**Response to Further Issue Letter**

17 Weinam & 57 Hamilton Streets, Redland Bay  
DEV2022/1290

### **Stormwater Management Response**

**RE: DEVELOPMENT APPLICATION DEV2022/1290**

Figure 6.1 Manning's Assessment – B(Ext) Diversion

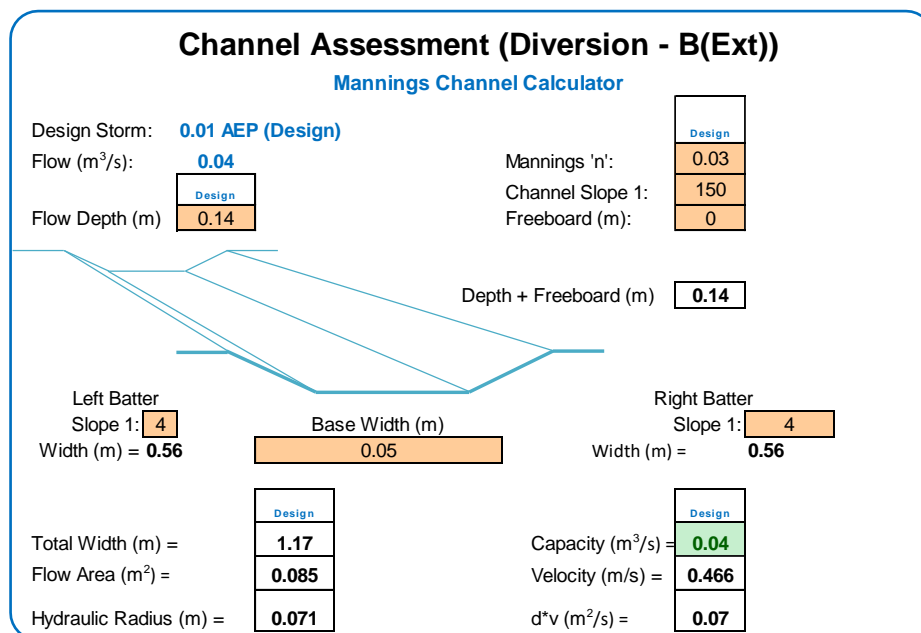
- Table 6.3 does not include catchment B bypass shown in Drawing DWG-201. Please clarify if the non-worsening demonstrated still applies for PD\_B.
- Clarify how mitigation is achieved for PD\_B. There are no detention structures shown for PD\_B catchments.
- The manning's assessment for open channel flow calculation has been done for a flow of 0.04 m<sup>3</sup>/s for the Pitt Street channel. However, the flow through the channel should be tested at full flow from the contributing catchments, which is higher.

- The manning's assessment presented in Section 6.1.1 of the report is for the proposed External Catchment B(Ext) diversion requirements. It is not for the exiting Pitt Street drain.

The peak discharge expected from External Catchment B(Ext) in the 1% AEP is 36 L/s. This assessment has been undertaken to set the level of the proposed foot path upgrade and upstream channel to direct flows to Pitt Street. A V-shaped channel with 1:4 batters at a slope of 1:150 will convey 40 L/s at a depth of 140 mm.

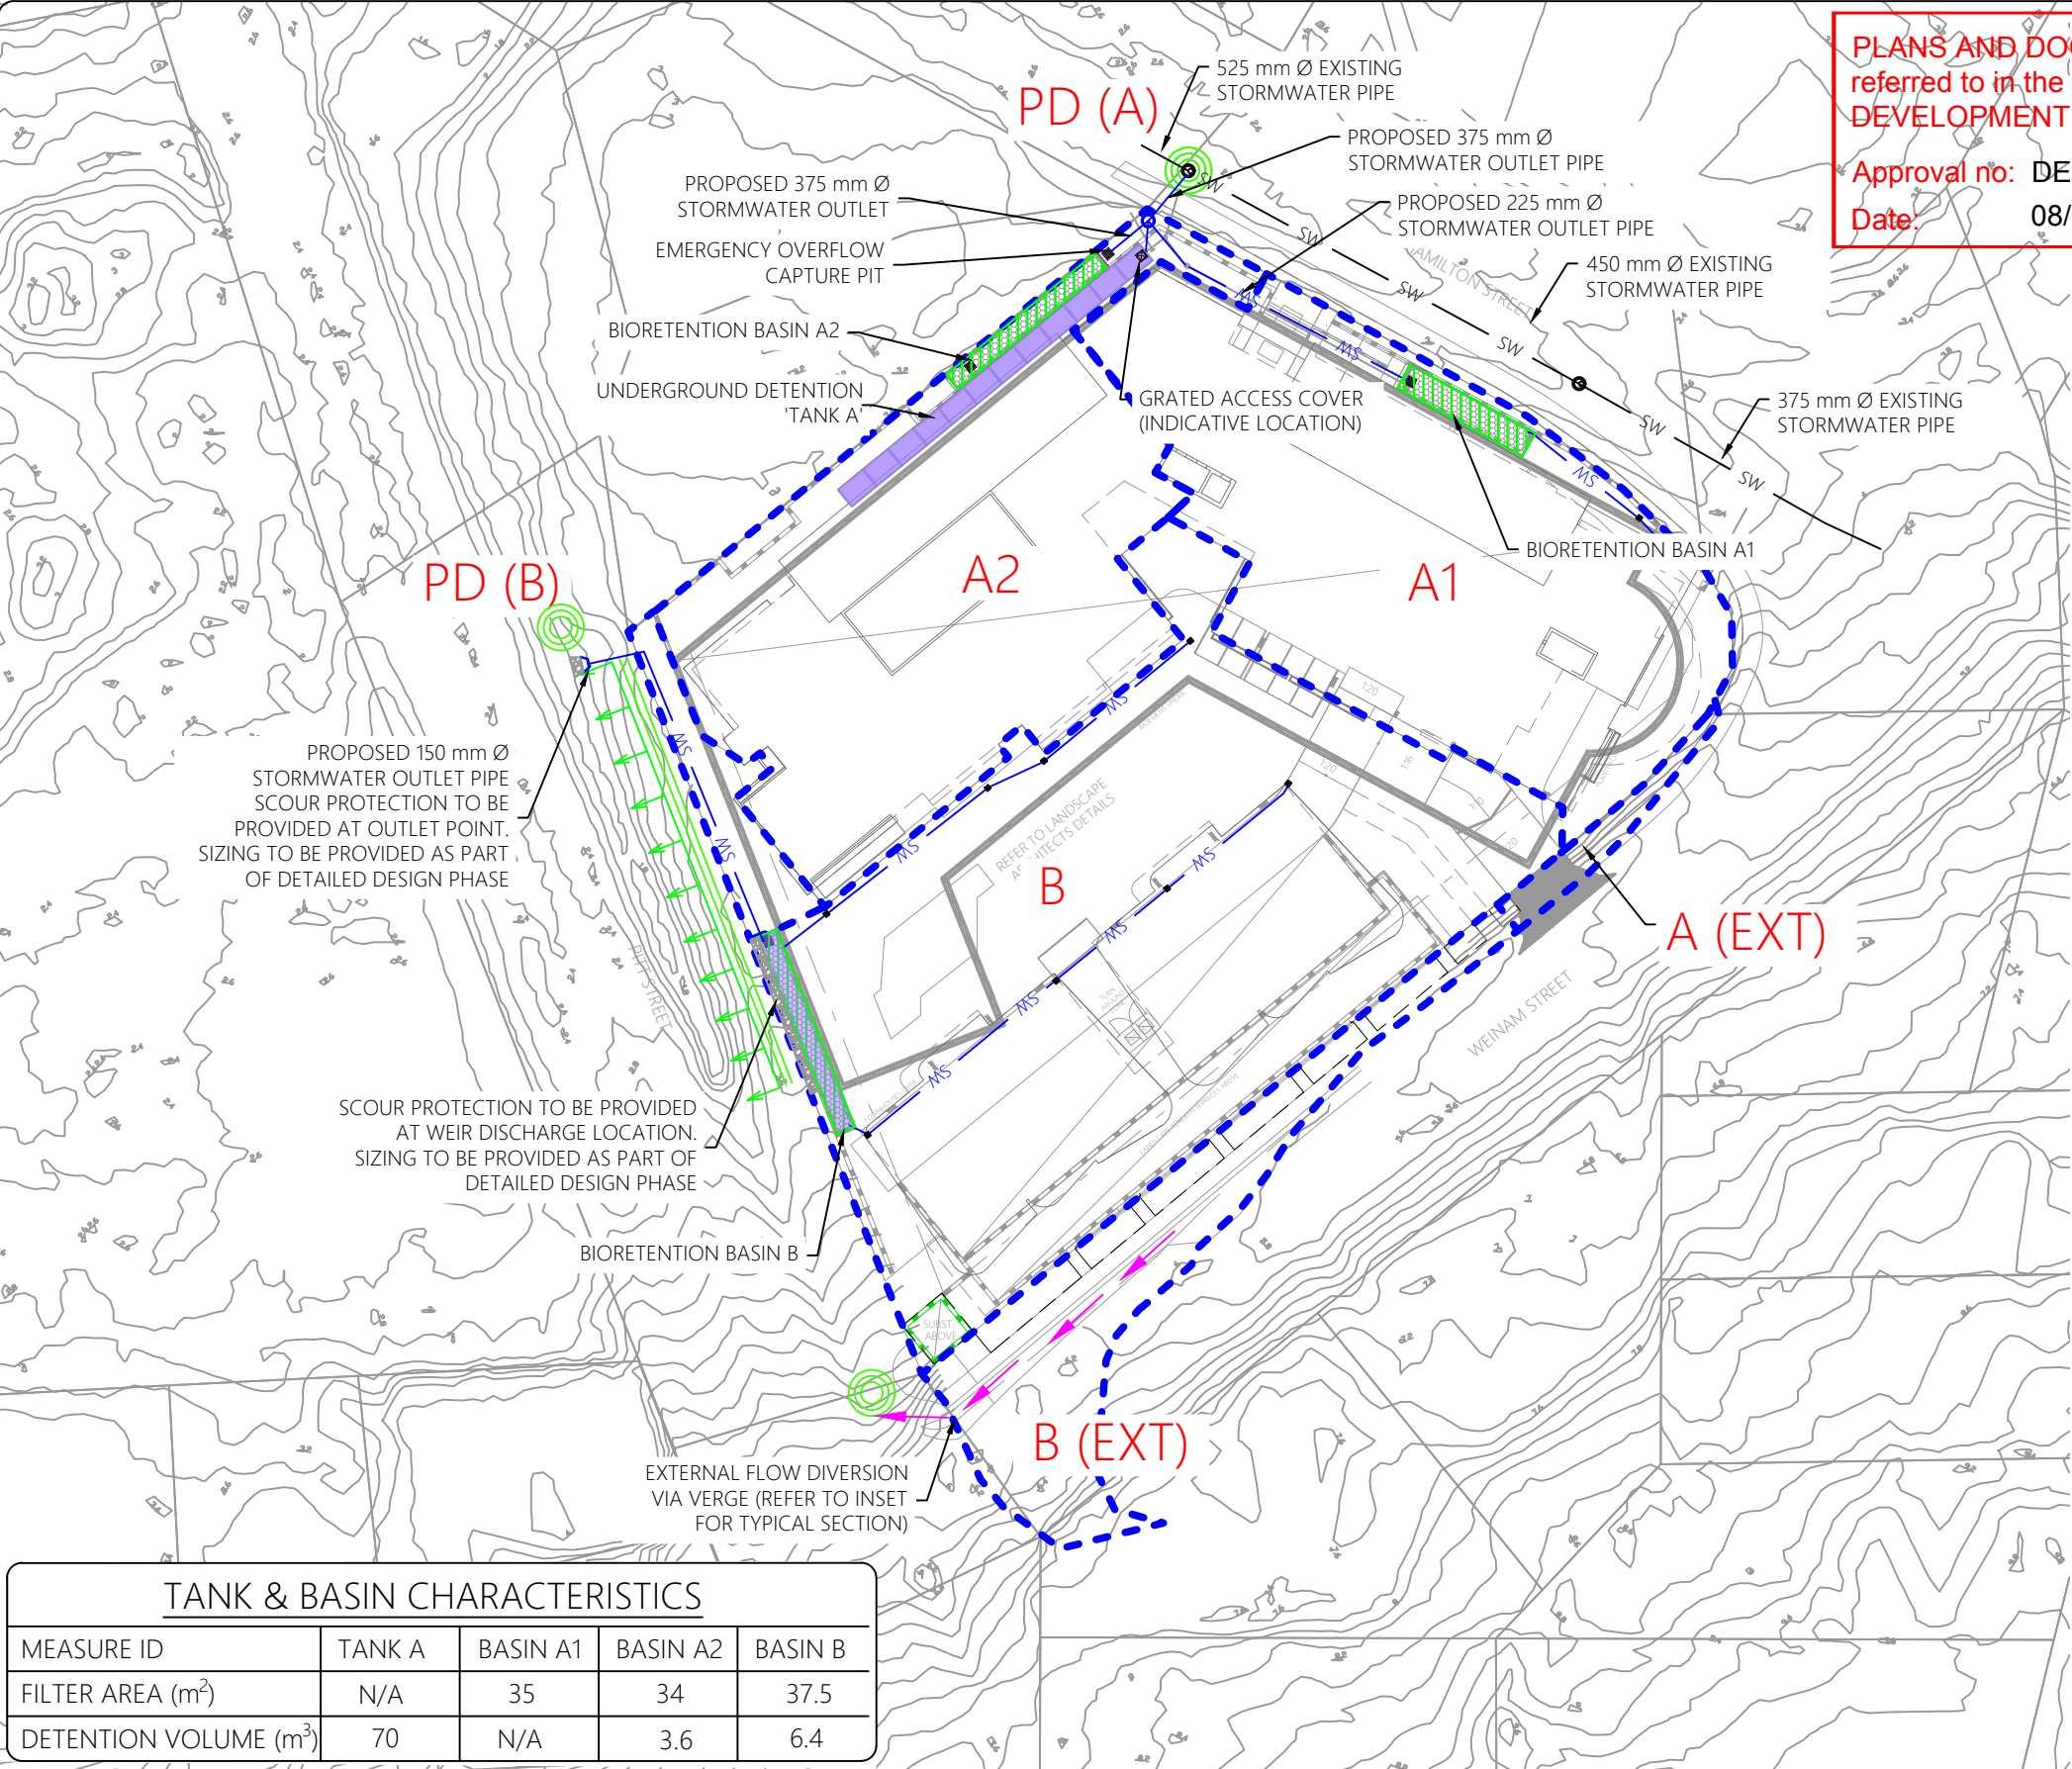
- a) Basin B scour protection is not shown on Drawing DWG-313 and should be updated to demonstrate scour protection.

- A note has been added to DWG-300 to nominate scour protection at the discharge headwall from the outlet pipe to the Pitt Street open drain.
- A rock scour has been shown on Section B-B DWG-313 on the downstream side of the proposed high flow weir.

1.6 M WIDE EMERGENCY OVERFLOW TOWARDS HAMILTON ST CREST @ R.L. 3.6

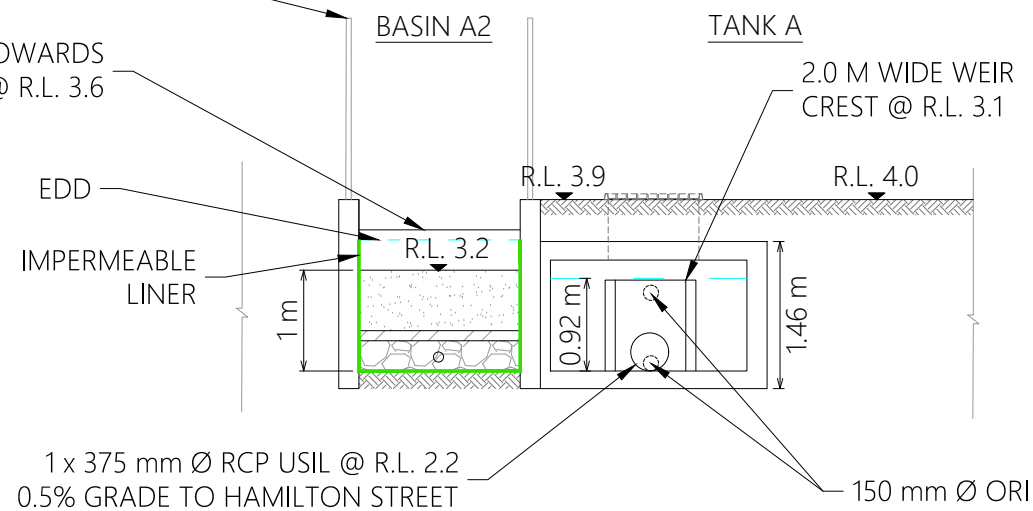
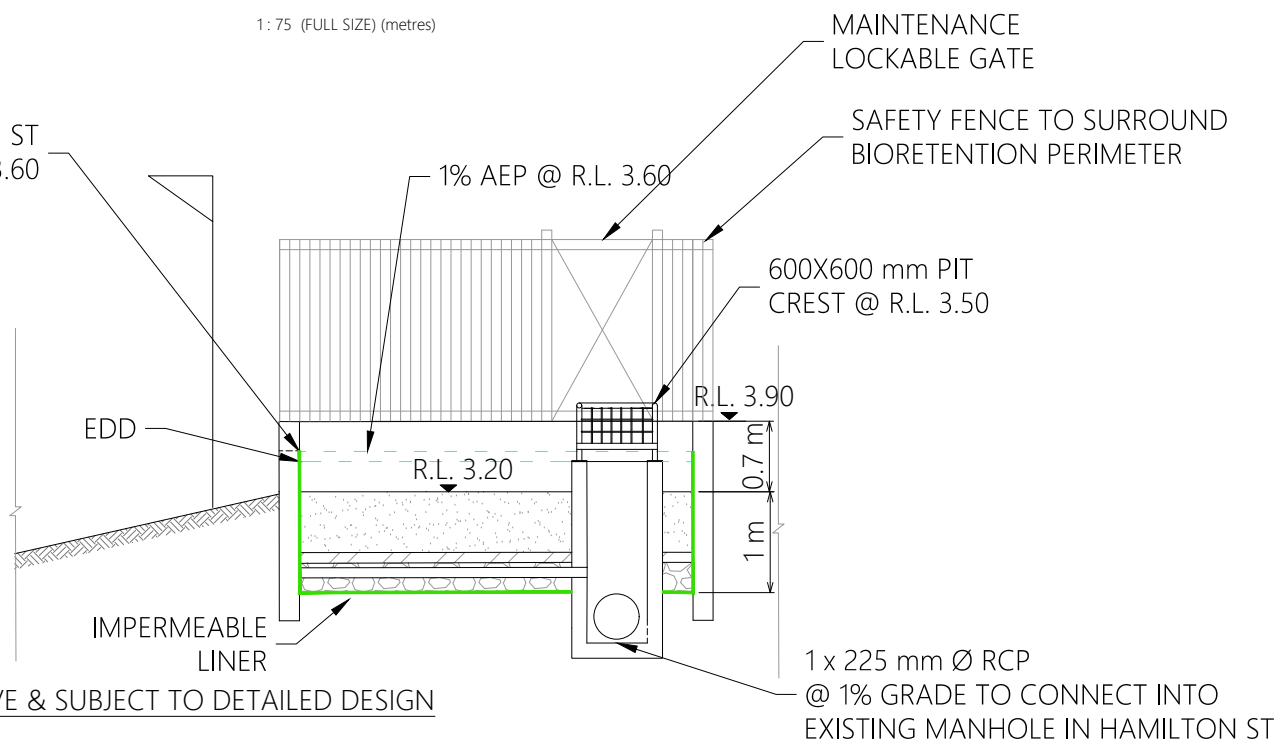
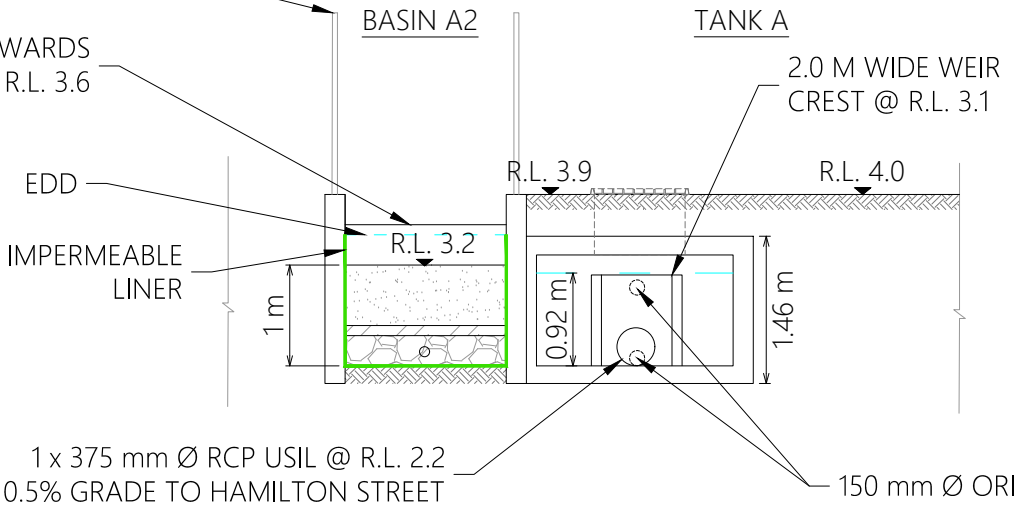
- b) It is noted in the SMP that Detention Tank A and Bioretention Basin A2 overflows are designed to sheet flow to Hamilton Street. The weir and passage available for flow are narrow and it appears the flow will channelise. Demonstrate how sheet flow is achieved.

It should be noted that flow will only occur over the emergency weir towards Hamilton Street in a block case scenario. The emergency weir will not engage in a design 1% AEP event.

An additional pit and pipe have been added on the downstream side of the emergency weir to convey flows to Hamilton Street.

Reference to sheet flow to Hamilton Street during a blocked case 1% AEP has been removed.
